UNITED STATES PATENT AND TRADEMARK OFFICE

APPLICATION NO.	FILING DATE	FIRST NAMED INVENTOR	ATTORNEY DOCKET NO.	CONFIRMATION NO.
09/681,441	04/05/2001	Peter Fall	VCC0031-US	4762

Office Action Summary

EXHIBIT

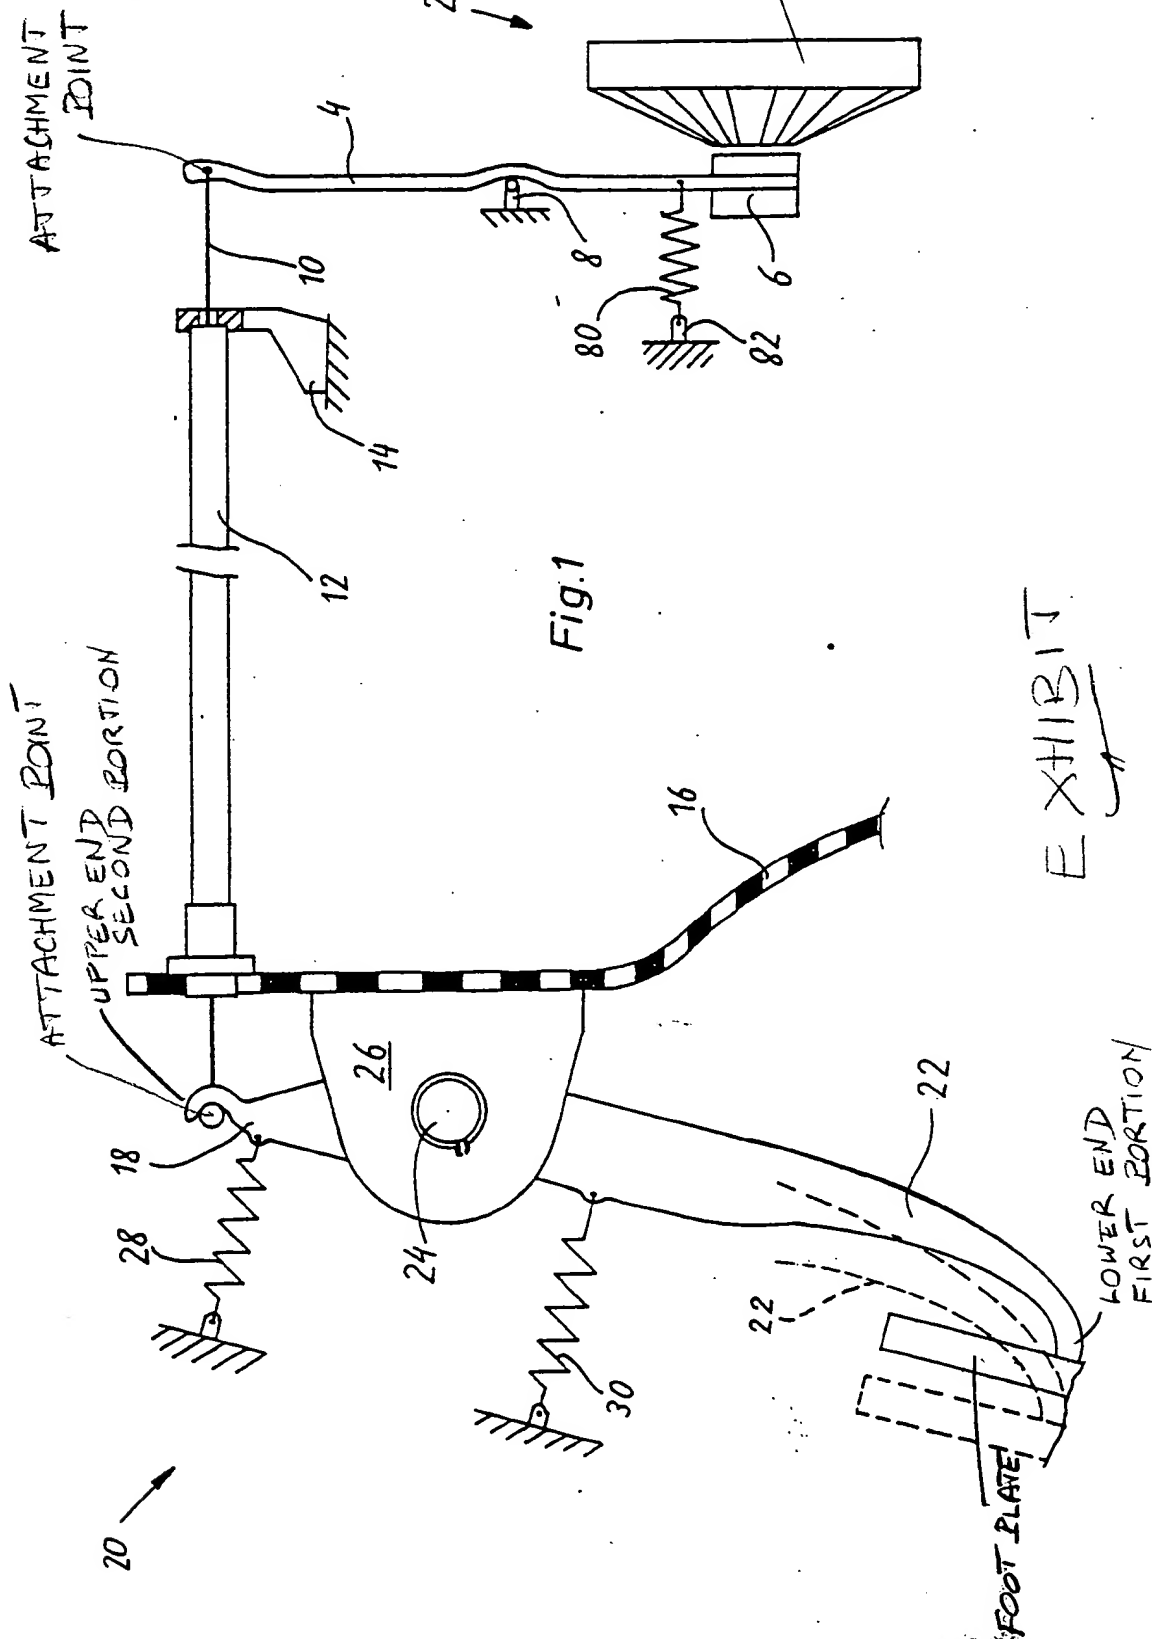
a foot plate (unnumbered, see Exhibit attached) fixed to a first portion (at 22 in Fig. 1) of the pedal arm 22 on one side of the pivot axis;

wherein the motion-transmitting element 10 is disposed so that the distance between the motion-transmitting element's attachment points (see Exhibit) to the respective arms (18 and 4) is maintained at least substantially constant when there is a tensile force on the element 10 (i.e., when the foot plate is moved downwardly as shown by solid line position in Fig. 1) and is allowed to be shortened when there is compressive force on the element 10 (i.e., when the foot plate is moved upwardly as shown in dashed line position in Fig. 1); and
